Global technical regulation No. 2 (WMTC)

Measurement procedure for two-wheeled motorcycles equipped with a positive or compression ignition engine with regard to the emission of gaseous pollutants, CO₂ emissions and fuel consumption

The text reproduced below was prepared by the WMTC FE experts in order to:

Figure 6-1: vehicle classification

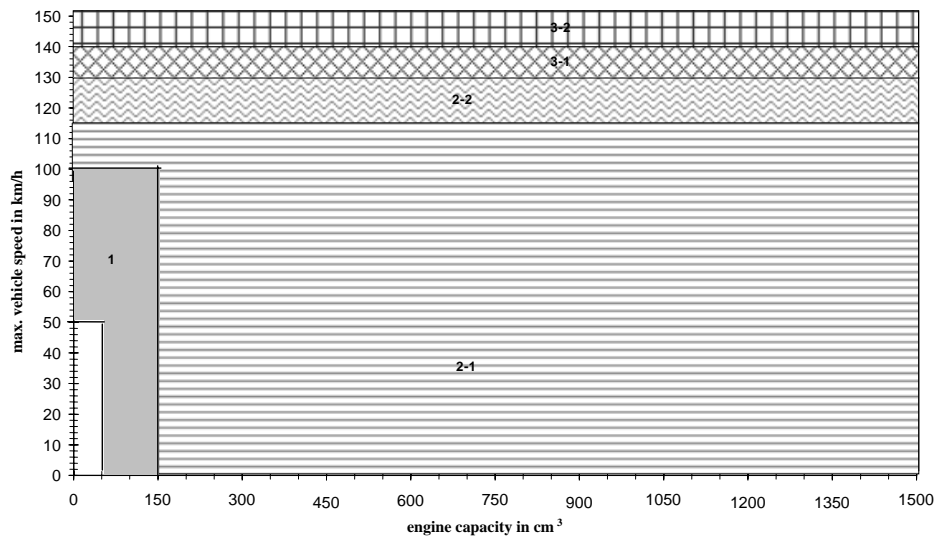
Section B.6.3.3., figure 6-1, substitute:

Justification: The amended figure graphically illustrates the new classification.

Section B. Annex 5, figure A5-1, substitute:

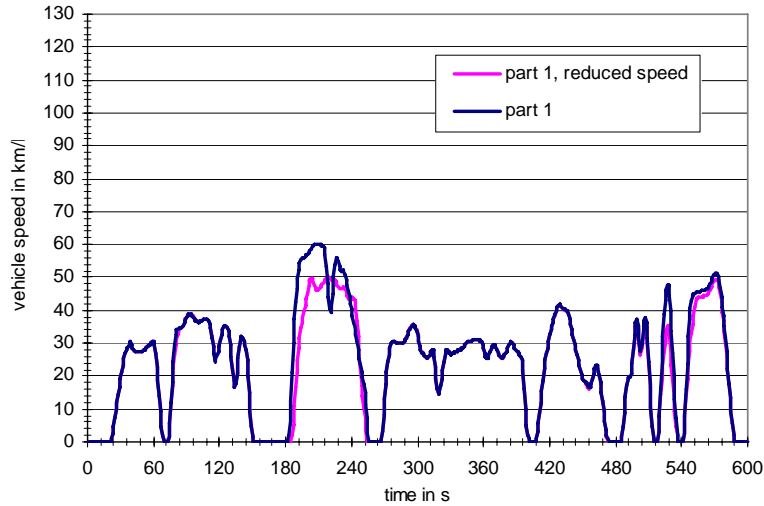
Justification: Amendment of test cycle part traces in line with cycle module modifications.

Section B. Annex 5, figure A5-2, substitute:

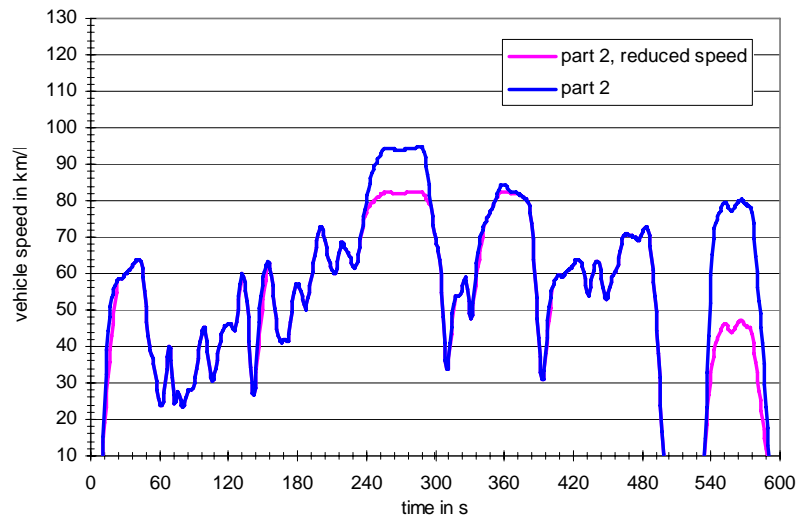
Justification: Amendment of test cycle part traces in line with cycle module modifications.
